# BAYSIDE COUNCIL

## Planning Assessment Report

Application Details	
Panel Reference:	PPSSEC-114
DA Number:	DA-2021/1
Date of Receipt:	12 January 2021
Property:	128 Bunnerong Road and 120 Banks Avenue Eastgardens
Owner:	
Applicant:	
Applicant Address:	Level 11, 528 Kent Street, Sydney
Proposal:	BATA Stage 2 - Lot E - Construction of a mixed use development comprising two residential flat buildings up to 17 storeys in height containing 322 residential units, communal recreational facilities, ground floor residential and retail, basement car parking; Publicly accessible through site pedestrian link; removal of three trees, construction and embellishment of two private roads and a future public open space component.
Recommendation:	Approval subject to Conditions
Value:	\$114,992,428.00
No. of submissions:	Six (6)
Author:	Fiona Prodromou - Senior Assessment Planner
Date of Report:	September 2021

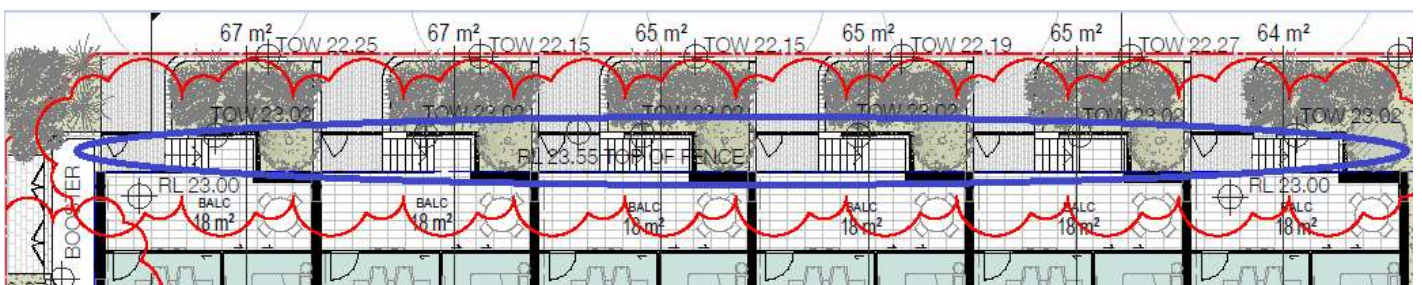
1.8m high open form fencing, forward of the building line, 1m from western property boundary. Such fencing is proposed to provide courtyards to units G02/G03/G07/G08 and is circled in blue below.

The provision of fencing forward of the building line to west facing units G02/ G03/ G07/ G08, in order to facilitate courtyards for these dwellings is not supported. The subject dwellings comprise sufficiently sized private open space areas adjoining habitable rooms and the enclosure of a portion of the deep soil zone forward of the building line is unnecessary in this regard.

Fencing in this area will conflict with proposed tree planting depicted within the Landscape plan, excerpt illustrated above, and should this area be strata subdivided and sold, it could potentially be modified with paving provided in future, thus reducing deep soil provision on site.

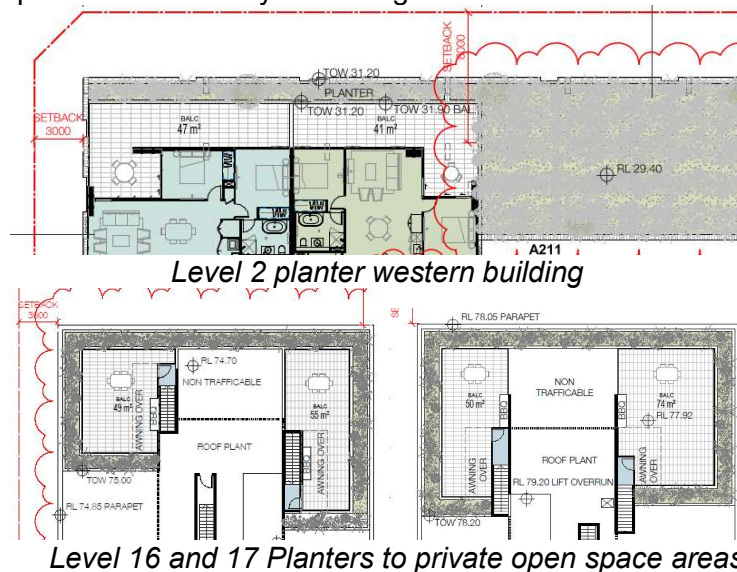
2m high fencing, forward of the building line, setback 2.6m from the northern property boundary. Such fencing is proposed to provide a secure residential entry and obscure the stairs to units G09- G14 and is circled in blue below.

With respect of the above, the provision of the stairs / landing and fencing to units G09- G14 is necessary in order to facilitate independent pedestrian entries to ground level units, given there is a level change between the public domain and finished ground floor level of units, as a consequence of the flooding affectation of the site. In this regard, the limited paved area and stairs/landing and fencing within the deep soil zone are satisfactory and supported, albeit subject to a reduction in height to 1.5m maximum as discussed in 3C – Public Domain Interface of this report.

As conditioned the proposal is satisfactory with respect of this concept plan condition.

*Fencing proposed to western elevation ground floor*

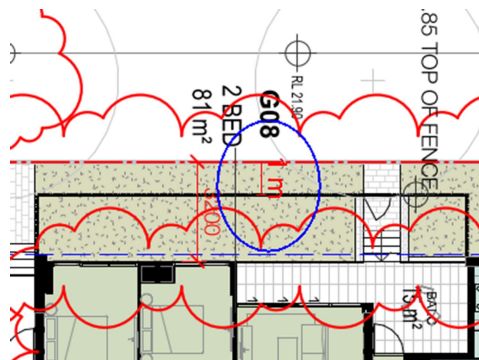
1.8m high open form fencing, forward of the building line, 1m from western property boundary. Such fencing is proposed to provide courtyards to units G02/G03/G07/G08.

Such courtyards are in addition to the 15sq/m of private balcony space provided to these units. The courtyard spaces are unnecessary from a compliance perspective, and the addition of fencing forward of the building line within what should otherwise be communal landscaping adjoining the public domain is unwarranted.

The proposal has been conditioned to require the deletion of such fencing and to limit the private open space of the aforementioned units to balcony spaces only, with the landscaped area forward of the building line to remain in common ownership with nil fencing in order to facilitate tree planting.

*Fencing proposed to northern elevation ground floor units*

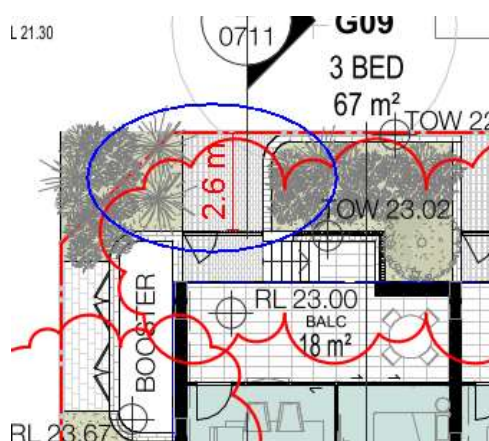
2m high fencing, forward of the building line, setback 2.6m from the northern property boundary. Such fencing is proposed to provide a secure residential entry and obscure the stairs to units G09- G14.
